To: INCITS Technical Committee T10
 From: Kevin Butt
 Date: Friday, June 19, 2009 10:21 am
 Document: T10/08-391r4 — SSC-3: Resolution to LB IBM-L1

This proposal intends to resolve LB IBM-L21:

Encryption Parameters in a SCSI device

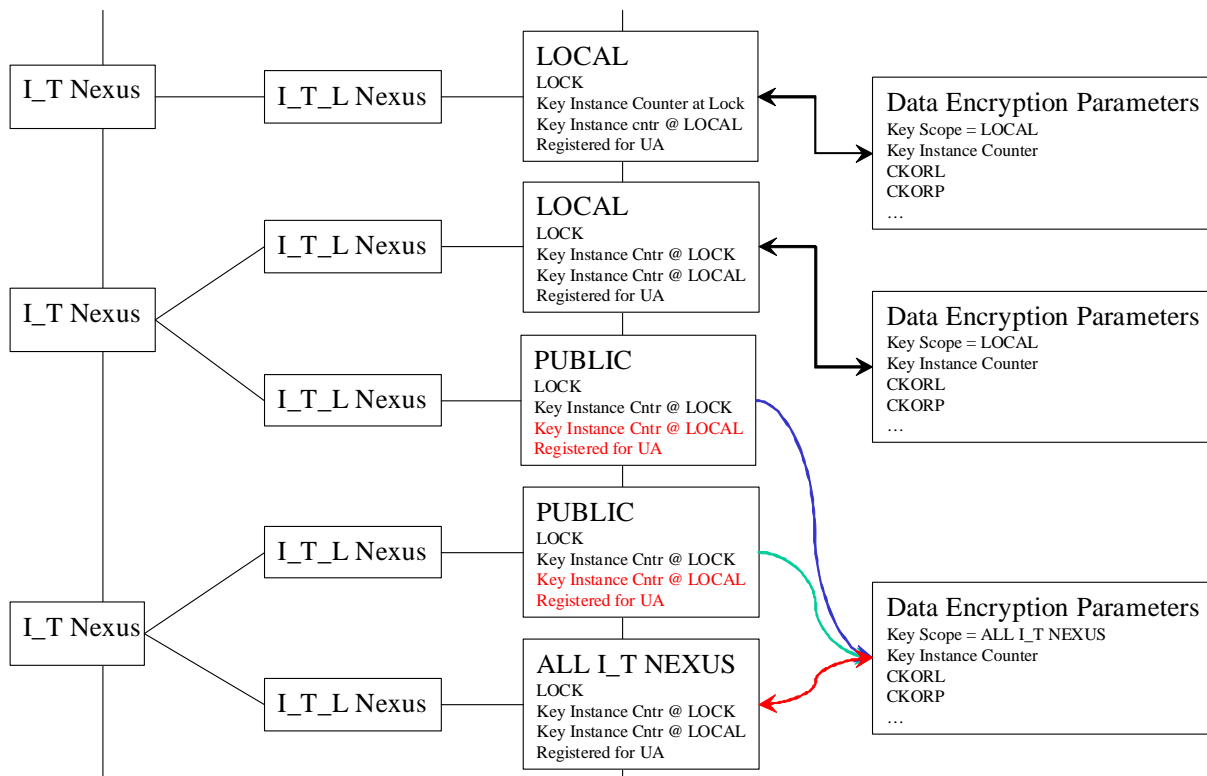
The following figure may help discuss the LOCK bit and what is required for it to function properly. Note that the red text in the figure are parameters that are not present in the specific case.
